To Teignbridge District Council:  
planning@teignbridge.gov.uk

**Discharge of conditions 5, 7, 8, 9, 11, 12, 16 & 21 on planning permission 15/01331/MAJ for hybrid application comprising: Full application for conversion of the existing threshing barn and associated linhay to form three dwellings and erection of 16 new dwellings with associated landscaping and access and outline application for dwellings including four gypsy and traveller pitches and public open space (approval sought for access)**

22<sup>nd</sup> March 2020

Image 3 – Design example of segregated infrastructure for vehicles, cycles and pedestrians. Note that widths are suitable for one way cycling – this design would need to be replicated on both sides of the street to be effective. Image credit to Sustrans.

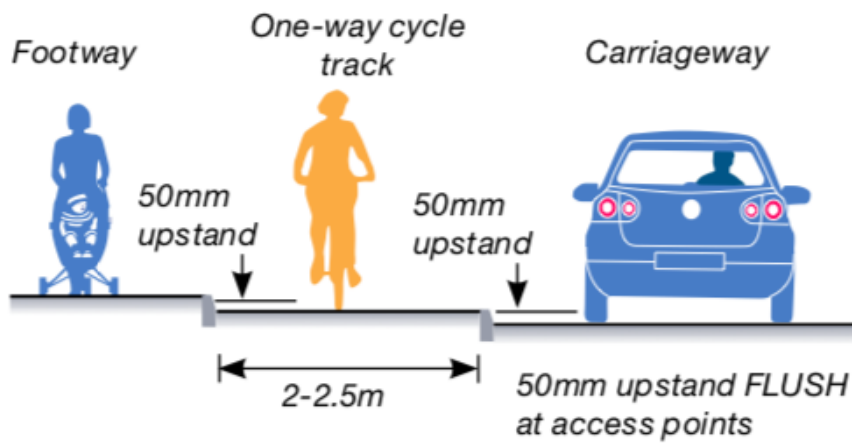
*A number of vehicular access points are noted on the plans. We would expect for the design to enable all modes of transport to safely use the access points currently marked as vehicular entrances. We also expect provision of full width pavements and for any major junctions, segregation for bicycles from both pedestrians and vehicular traffic. The design should also include:*

- 1. Dropped curbs where appropriate to allow filtered permeability. See image 1 in appendix 1 for an example where this has not been completed and has resulted in access issues for many users.*
- 2. If bollards are used to prevent vehicular traffic, adequate space should be allowed for non-standard cycles (i.e. cargo bikes, trikes and trailers). Where possible staggered fencing and gates should be avoided. This guidance should also be applied to the entrances and exits to the green spaces.*

Image 5 – A second aerial view of a section of the A379, showing unused space that could be reallocated to provide improved pedestrian / cycle facilities.

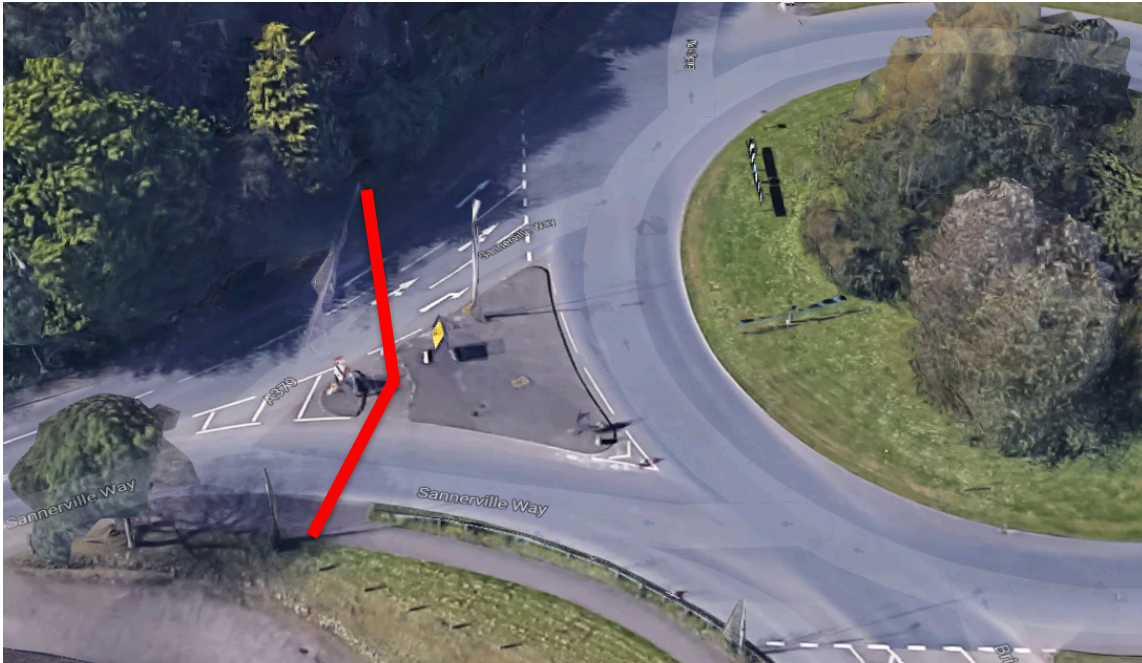
- 2. Kennford – Currently a very poor quality, narrow footpath is available along the A379, however this is often not passable by foot or bike, due to the narrow width, uneven surface and overgrowth of weeds and brambles. Kennford has a number of facilities, which the residents of the new development may wish to access including a community centre, cycle shop and post office. It is essential that this path is re-designed and re-built to a much higher specification in order to prioritise those choosing to walk and cycle. See images 4 & 5 in*
